# 45 Bury Mead Road, Hitchin

## Highways Response Note Addendum

Client: Hitchin Mosque

Job No 328985

Figure 5.5 Key Route Plan

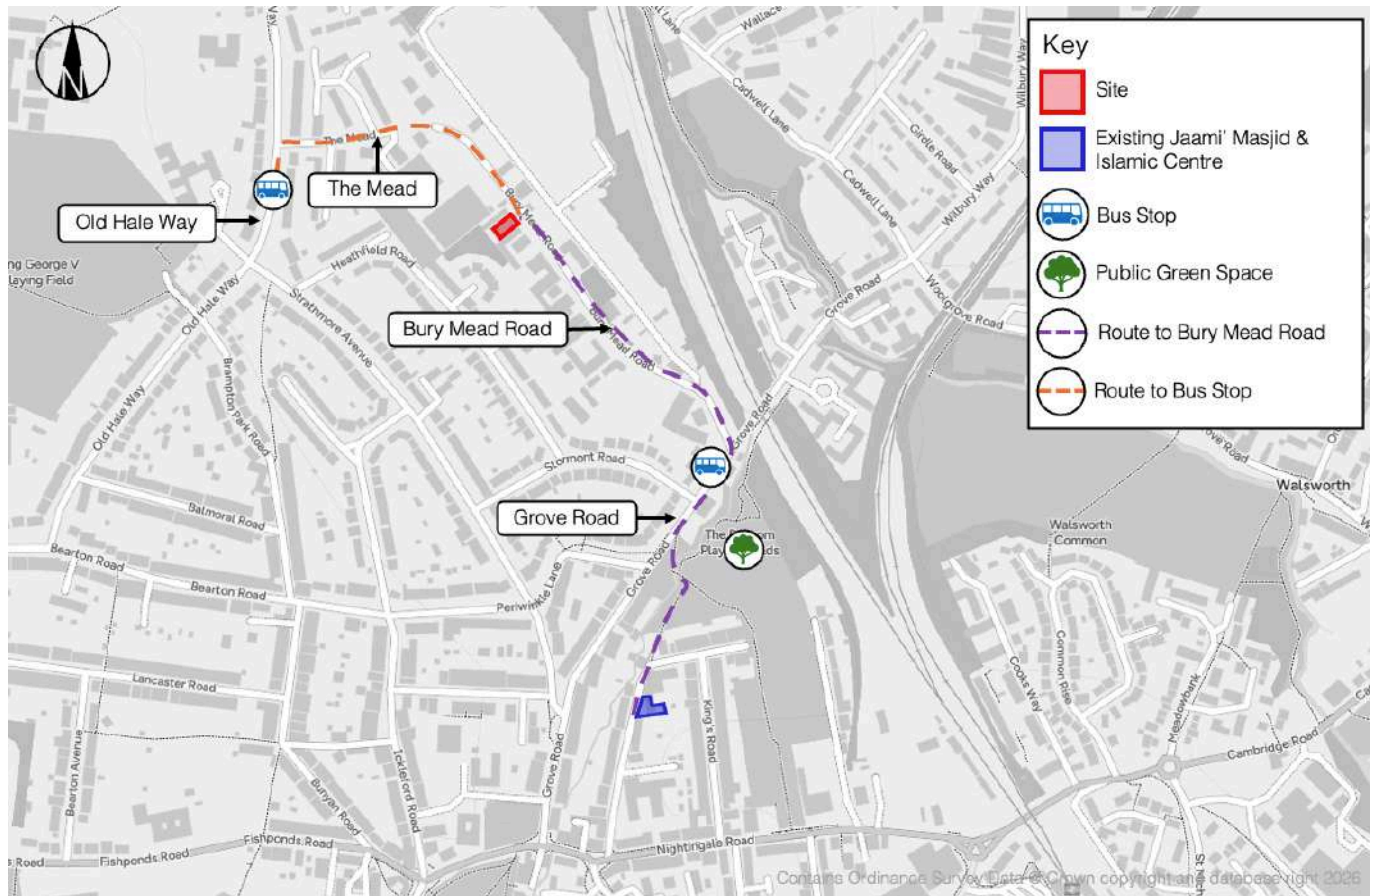
While bus stops are located approximately 450- 500m away, the route to them is not pedestrian-friendly and does not provide a safe or attractive alternative to car travel.

5.5.5 A key route plan is provided in **Figure 5.5**.

5.5.6 A review of congregants' places of residence indicates that, while some live to the west of Hitchin Station and near Nightingale Road/ Grove Road, larger clusters are located within Walsworth and around Strathmore Avenue. Consequently, the majority of congregants already reside to the north of the existing Jaami' Masjid & Islamic Centre. It is therefore anticipated that congregants will primarily use The Mead and Grove Road to access the proposed mosque on Bury Mead Road.

**Figure 7.1 Location of Respondents' Residences**

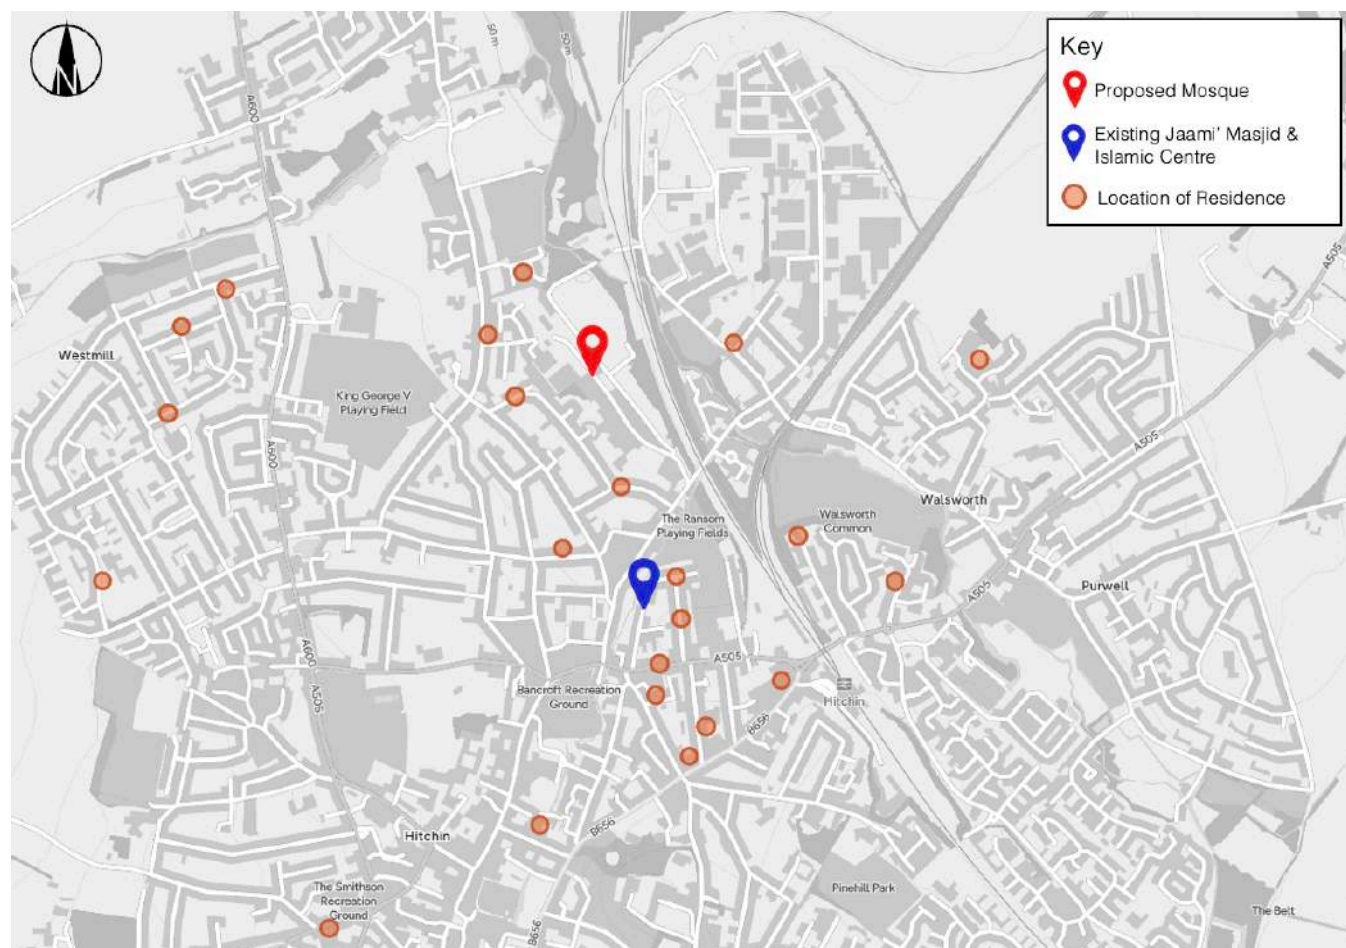
The applicant's updated travel survey assumes similar travel behaviour to the existing residential site and ignores key contextual differences, greater distance from residential areas, poor pedestrian infrastructure, absence of CPZ controls, and industrial traffic hazards, likely increasing car use and unmanaged parking. The question "How will you travel to the new mosque?" is leading and does not reflect real-world conditions.

The proposition that future patterns can be "accurately determined" from a single question posed to a residentially biased sample overstates certainty and does not account for route quality, personal safety perceptions, kerbside pressures, and enforcement absence.

7.3.3 **Figure 7.1** illustrates the approximate locations of the postcodes collected in the survey, representing respondents' places of residence. Duplicate postcodes are shown only once. Two postcodes are not displayed due to the map scale; these are located to the north, in Letchworth Garden City.

- 7.3.17 On this basis, the previous mode shares applied are supported by the revised travel survey and, as such, support the conclusion that the majority of congregants will walk to the mosque.

Figure 9.1 Indicative Location of Proposed Measures on Bury Mead Road

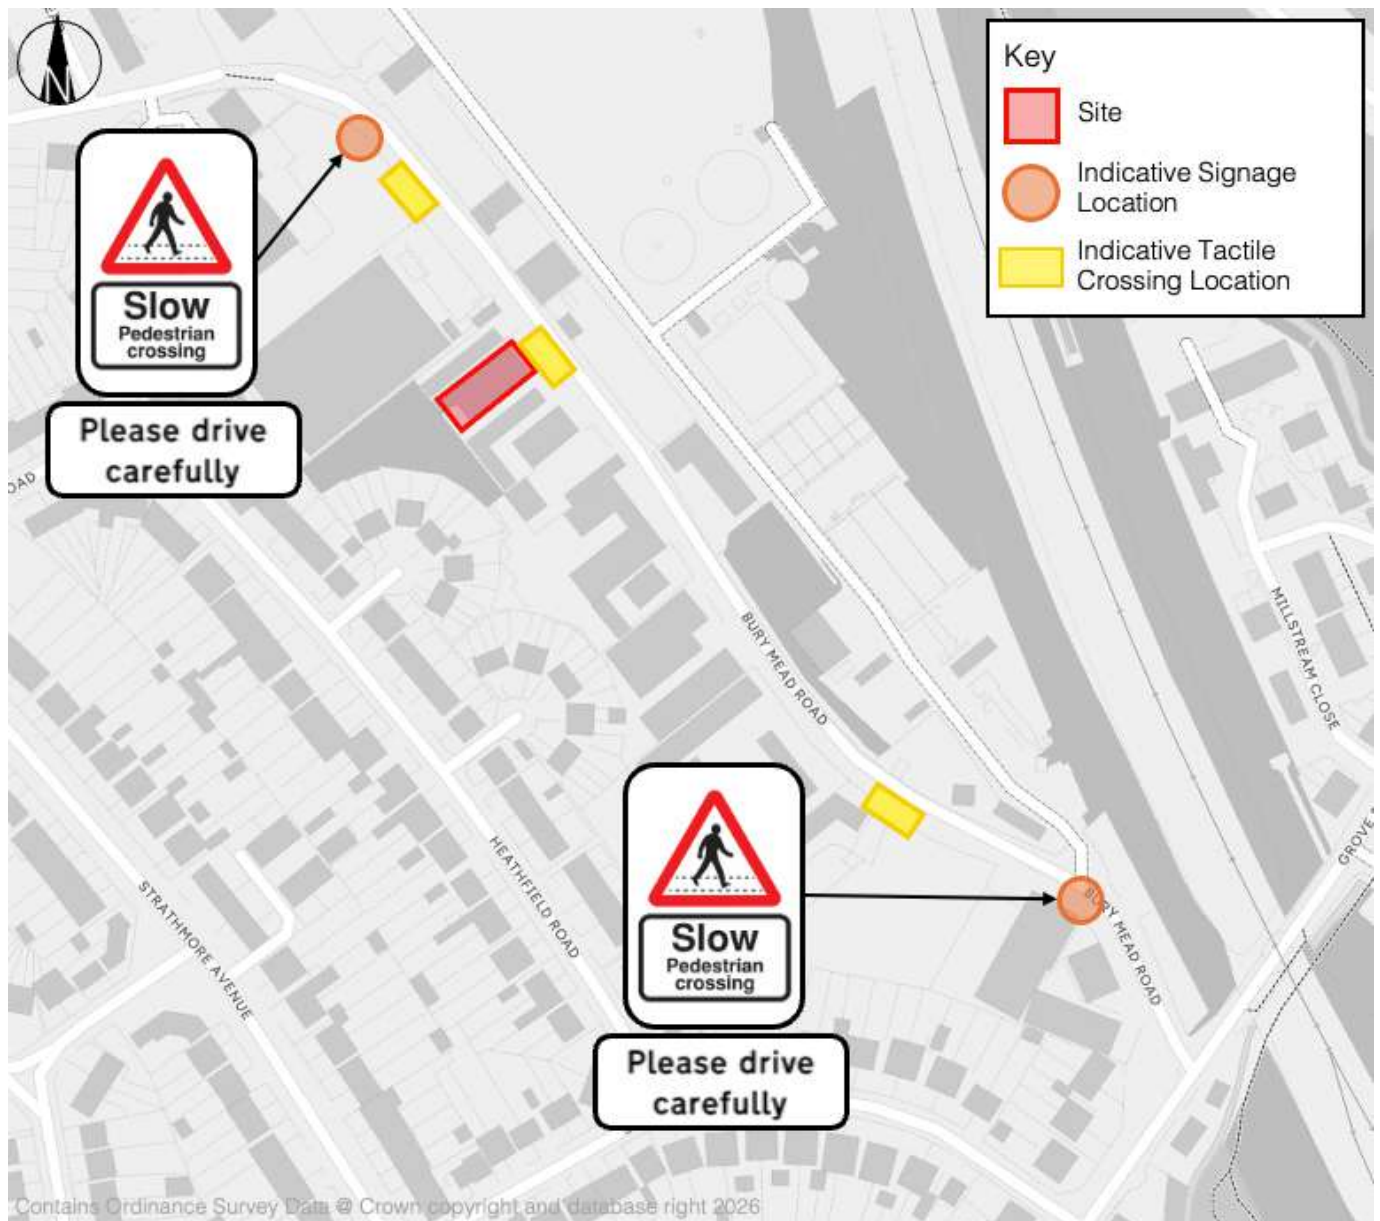
- 9.2.1 The Independent RSA, as outlined in [Section 5](#), identified a number of potential hazards associated with pedestrian activity, parking behaviour and peak arrival periods associated with mosque attendance. In response, a range of potential control measures have been explored to minimise any potential risk and ensure that pedestrian safety is maintained.

- The provision of signage at the start and end of Bury Mead Road to alert drivers to pedestrian activity associated with the site. This will act as a gateway feature and encourage sensible driver behaviour, as well as noting pedestrians are in the area on Bury Mead Road. Signage is to be confirmed with HCC.

- Maintaining existing visibility splays at the site access points to ensure visibility between drivers and pedestrians.
- 9.2.4 For reference, [Figure 9.1](#) illustrates the locations of indicative signage and tactile paving that are proposed along Bury Mead Road.

9.2.5 The nature and extent of any physical measures would be in consultation with the Highway Authority and would be proportionate to the scale of development, the characteristics of the existing highway environment and the infrequent nature of peak attendance events.

mode Drawings Site Layout

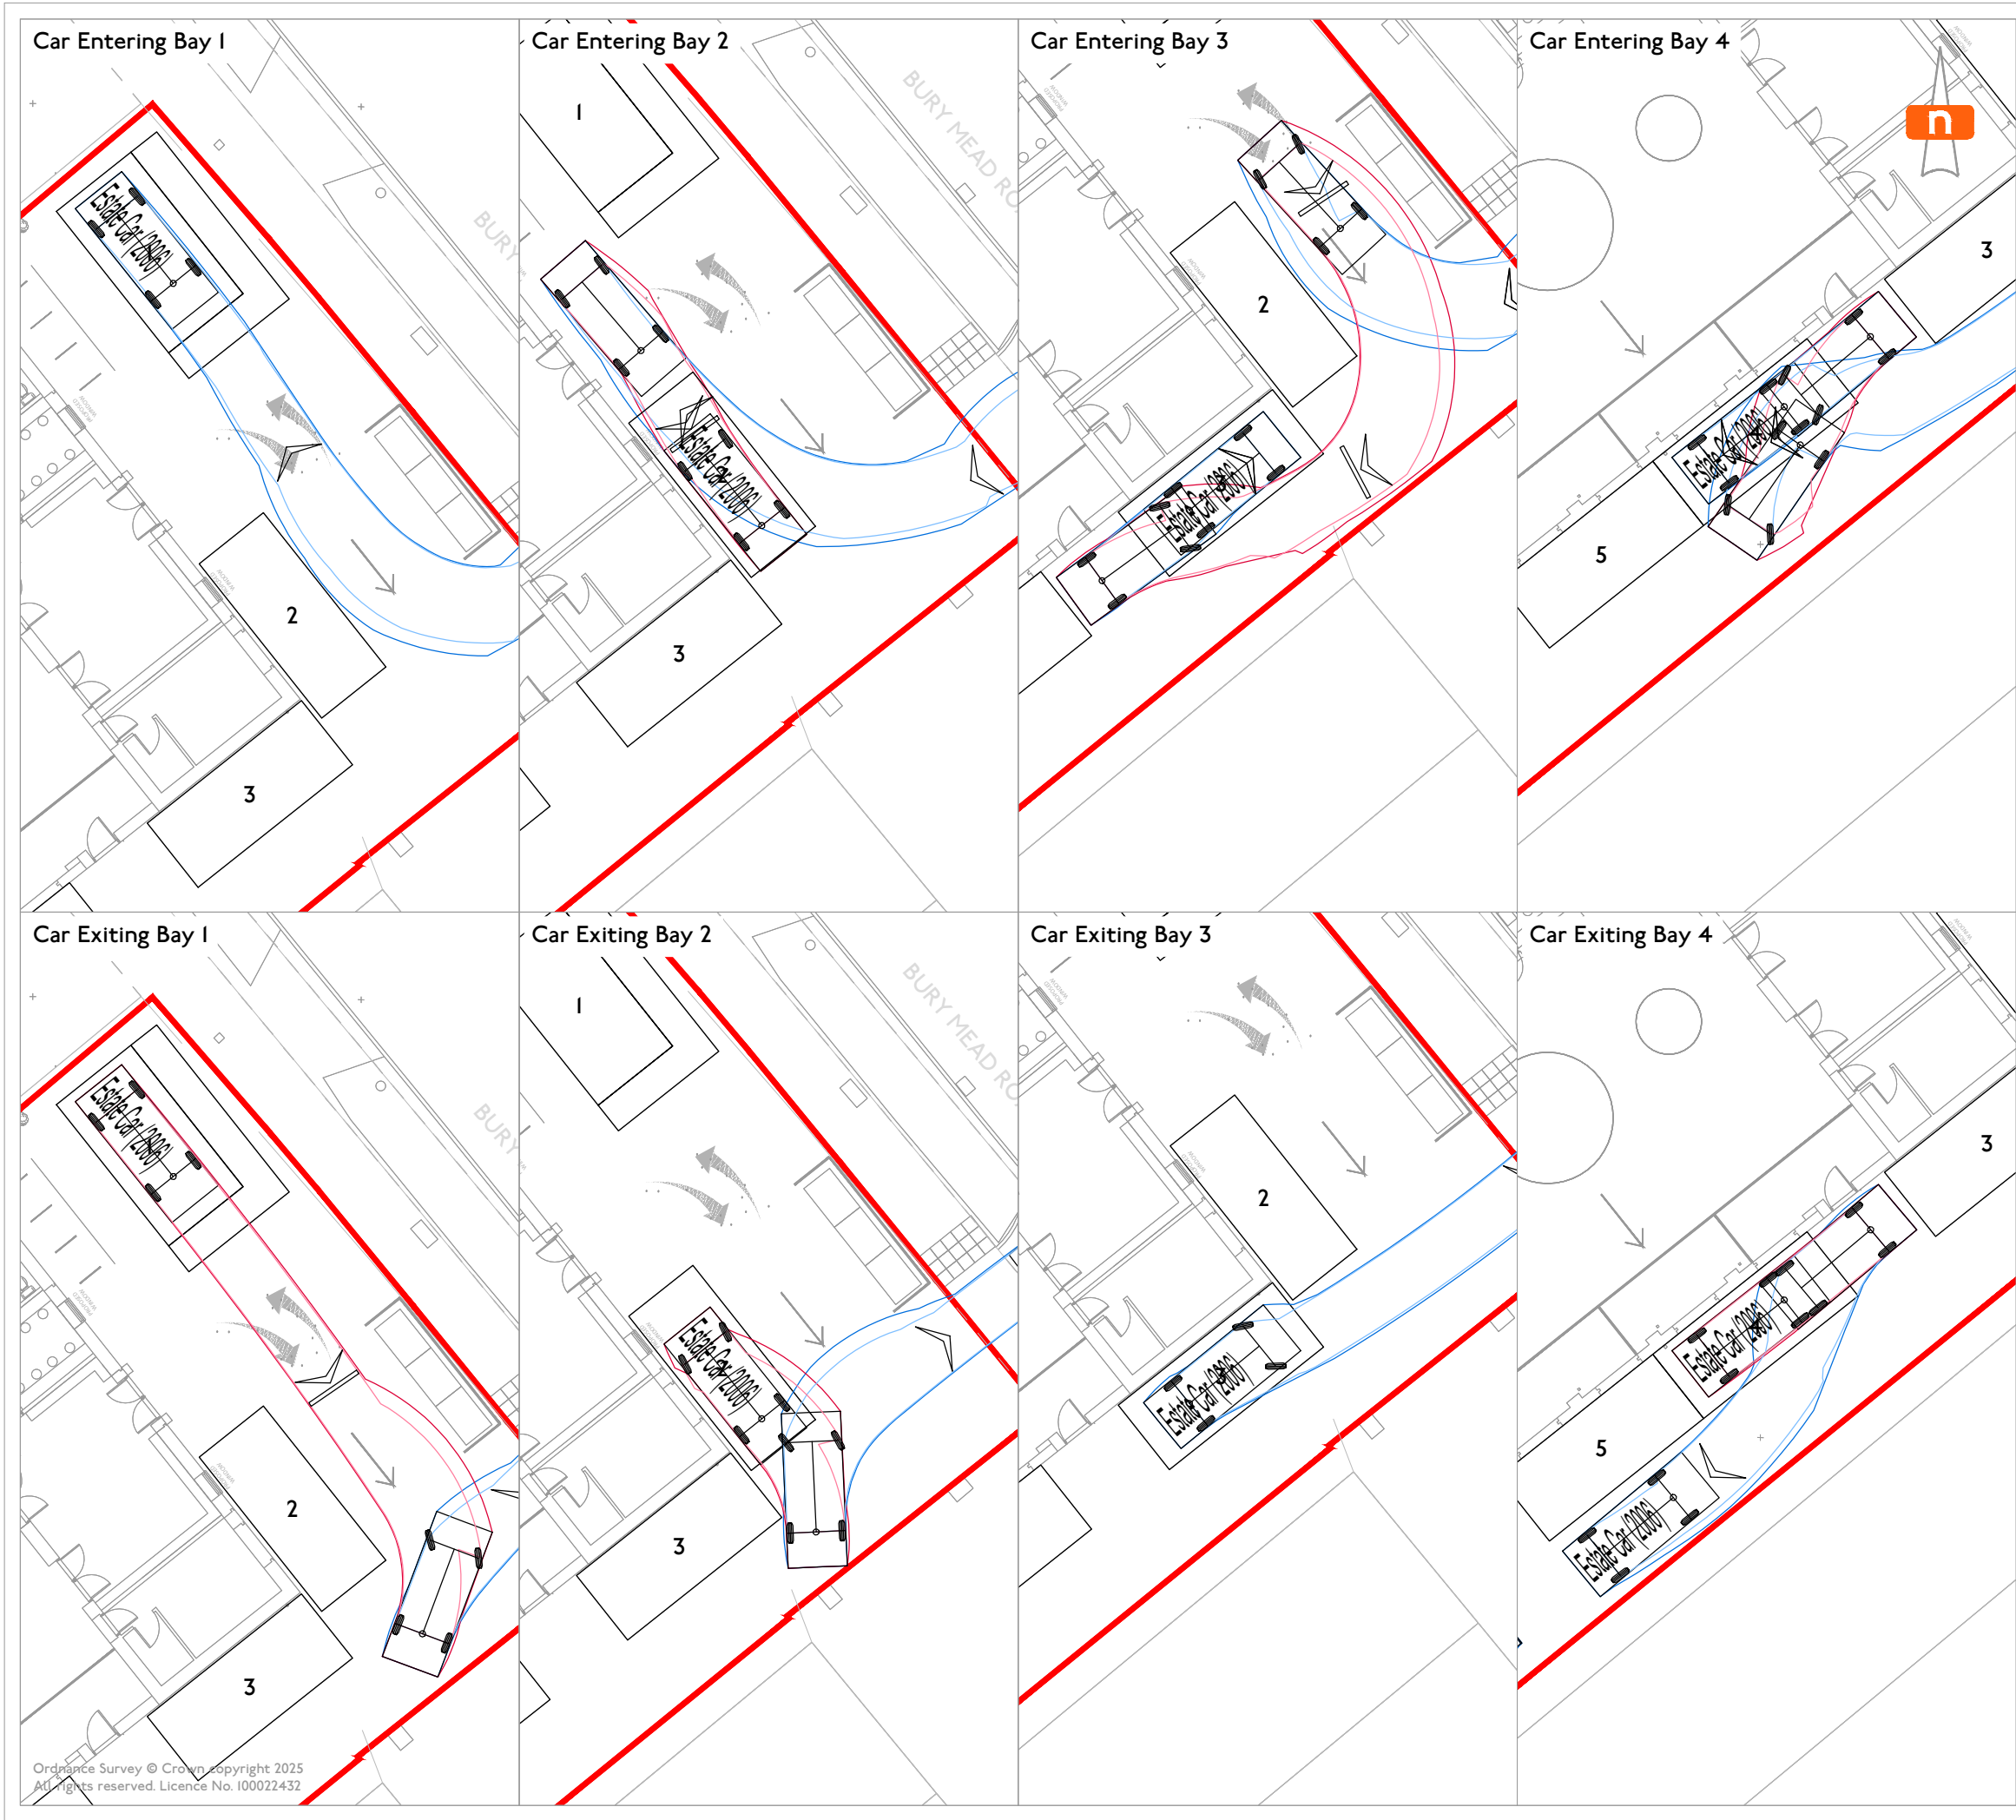
4.1.1 HCC considers that the current cycle parking layout requires further clarification and dimensional detail to demonstrate compliance with national cycle design guidance and to ensure convenient, safe, and practical access for users. HCC has also recommended a review of manoeuvring space, pedestrian visibility and car parking bay confirmation. HCC notes that the car parking arrangement would benefit from further refinement to improve pedestrian safety and compliance with relevant design standards.

4.1.2 In response to HCC's comments, the site layout has been revised to address the comments raised. The amended layout, provided in [Appendix B](#), incorporates adjustments to cycle parking dimensions, manoeuvring space, and car parking arrangements to ensure compliance with relevant design guidance and to ensure safety and accessibility for all users, which is further considered below.

4.2.3 Vehicle tracking has been carried out to ensure safe manoeuvring across the site, and the number of car parking spaces has been reduced to allow additional space for turning. The car parking bays have been designed in accordance with HCC's Place & Movement Planning and Design Guidance for Hertfordshire (2024), with the standard bays measuring 6m x 2.5m and the disabled bay measuring 6.5m x 3.9m. A turning area is available at the rear of the site, and **mode drawing J32-8985-A01** and **A02**, provided in **Appendix C**, demonstrate that an estate car can manoeuvre in and out of all parking bays.
